UNITED STATES PATENT AND TRADEMARK OFFICE

APPLICATION NO.	FILING DATE	FIRST NAMED INVENTOR	ATTORNEY DOCKET NO.	CONFIRMATION NO.
10/523,896	11/02/2005	Arthur Raymond Winn	BMADD 1031736	9489
27111	7590	06/11/2009	EXAMINER	
GORDON & REES LLP 101 WEST BROADWAY SUITE 1600 SAN DIEGO, CA 92101			VOLZ, ELIZABETH J	
			ART UNIT	PAPER NUMBER
			3781	
			NOTIFICATION DATE	DELIVERY MODE
			06/11/2009	ELECTRONIC

Office Action Summary	Application No. 10/523,896	Applicant(s) WINN ET AL.	
	Examiner ELIZABETH VOLZ	Art Unit 3781

DETAILED ACTION

Figure 12 (Schurch)

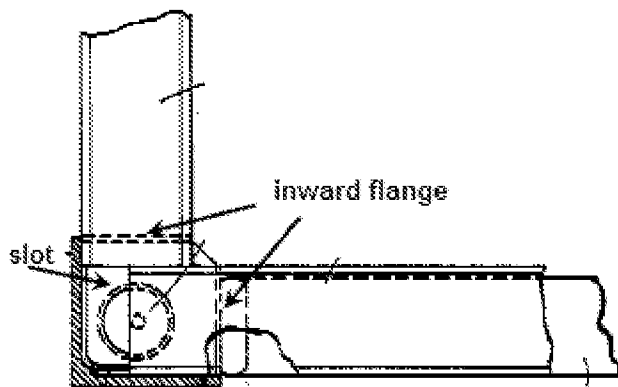
6. Regarding Claim 2, Schurch discloses a first perimeter frame attachment member 12 (Figure 1) which is an approximate C-section post 42 (Figure 12) which terminates at one of its ends in said laterally inwards directed locking flange, the free edge of said locking flange (Figure 1 above) being spaced laterally outwards from the vertical margin of the outer frame, and at its other end in an inturned inwardly directed attachment flange arranged to be attached to a respective said vertical margin (Figure 1).

9. Regarding Claims 6 and 19, Schurch discloses each said side gate is provided with an angle section frame member (Figure 1 above) extending along each of its vertical margins, each angle section frame member having one of its flanges (Figure 1 above) abutting the inner face of the infill panel, and its other flange (Figure 1 above) extending rearwardly and lying parallel to a vertical margin of the outer perimeter frame, said other flange being spaced from said vertical margin so as to define an elongate slot (Figure 1 above) for receiving a respective said attachment flange of a said C-section post 42 (Figure 12).

above) perpendicular to the clamping flange, the outwardly facing flange forming an outwardly facing flange-receiving slot (Figure 1 above) extending the entire length of the vertical end face of the vertical frame member; an infill panel (Figure 1 above) removably clamped to the two opposite vertical frame members by the vertical clamping members, the clamping flanges of each clamping member abutting against an inner surface of the infill panel; and four C-section posts 42 (Figure 12), one C-section post being removably attached to each vertical frame member of the two opposite side gates, each C-section post having two perpendicular inwardly facing flanges (Figure 12 below) located within the outwardly facing flange-receiving slots (Figure 12 below) of the vertical end faces of adjacent side gates and end gates (Figure 12).

18. Regarding Claim 5, 7, 16, 18, 20 and 21, Schurch discloses detachable securing means 35 (Figure 3) movable between an extending locking position wherein each locking bolt passes through an aperture (Figure 1 above) formed in said attachment flange of the C-section post 42 (Figure 12) and a retracted unlocked position, in which position the C-section post can be detached from its associated said gate (Column 4, Lines 11-13). Schurch does not disclose the detachable securing means to be spring-loaded locking bolts. However, Ryziuk et al. teaches spring-loaded locking bolts 10 (Figure 2a; Column 13, Lines 7-29). Therefore, it would have been obvious for one of ordinary skill in the art at the time the invention was made to modify Schurch to include spring-loaded locking bolts, as taught by Ryziuk et al., in order to keep the bolts from accidentally sliding to an unlocked position.

19. Regarding Claim 17, Schurch discloses each side gate which is provided with an angle section frame member (Figure 1 above) extending along each of its vertical margins, each angle section frame member having one of its flanges (Figure 1 above) abutting the inner face of the infill panel, and its other flange (Figure 1 above) extending rearwardly and lying parallel to a vertical margin of the outer perimeter frame, said other flange being spaced from said vertical margin so as to define an elongate slot (Figure 1 above) for receiving a respective said attachment flange of a said C-section post 42 (Figure 12).

Figure 1 (Brown)

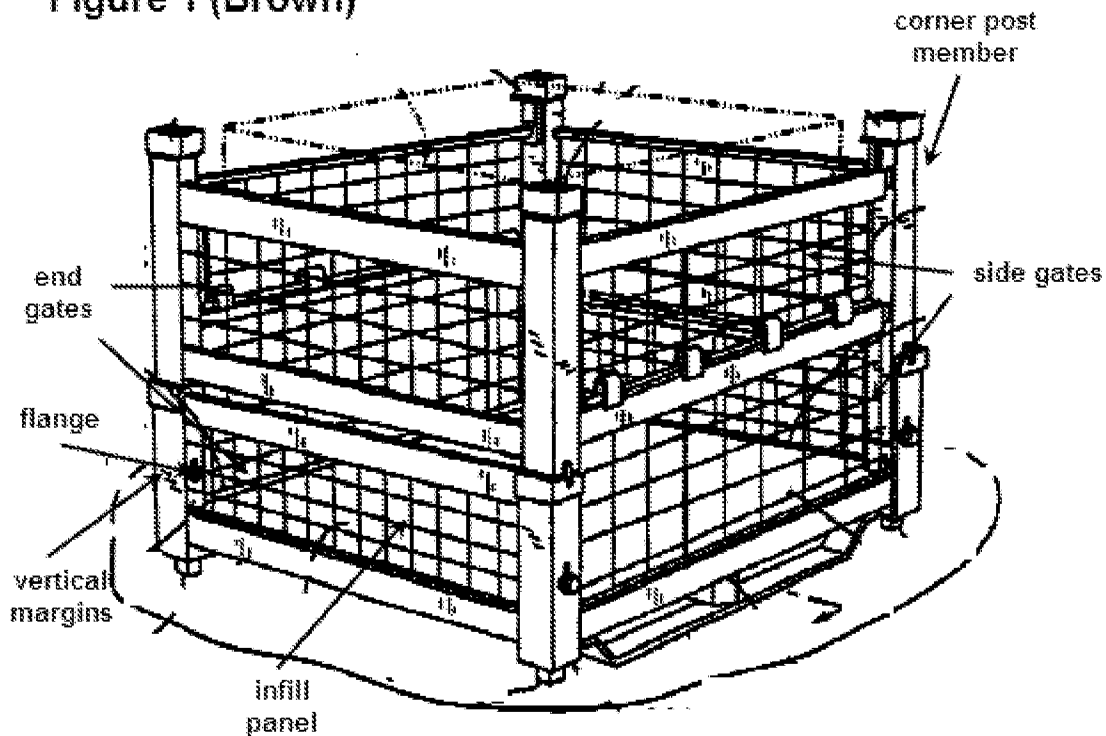
12. Regarding Claim 8, Brown discloses a collapsible storage container 10 (Figure 1) comprising a base 12 (Figure 1); two pairs of opposite side gates (Figure 1 below) and

two pairs of opposite end gates (Figure 1 below), each said gate pivotally mounted with respect to the base for folding movement between an erect in-use position (Figure 1) and a collapsed position (Figure 4) on top of the base, each said gate having an infill panel 122 (Figure 5) having an inner face and an outer face (Figure 5), and an outer perimeter frame secured to the outer face of the infill panel so as to define at least vertical margins (Figure 1 below) thereof; said adjacent vertical margins of adjacent said gates when in their erect in-use positions, being interconnected by a corner post member (Figure 1 below) detachably secured to and abutting each said vertical margin, each said corner post member having a pair of inwardly directed locking flanges (Figure 7) which respectively locate in outwardly opening flange receiving slots (Figure 4) on the vertical margins of adjacent gates when the gates are in their erect in-use positions, the corner post members extending along the vertical margins of the gates there being locking means 68 (Figure 18) for releasably locking each within its associated said flange receiving slot.

13. Regarding Claim 9, Brown discloses each of the gates has a two-flanged elongate angle frame member extending along each of its vertical margins with a first flange (Figure 1 above) abutting the inner face of the infill panel and a second outwardly directed flange 68 (Figure 18) extending parallel to the vertical margin of the gate and spaced outwards therefrom so as to define said outwardly opening flange receiving slot 48 (Figure 11) extending along the entire length of the vertical edge of the gate.
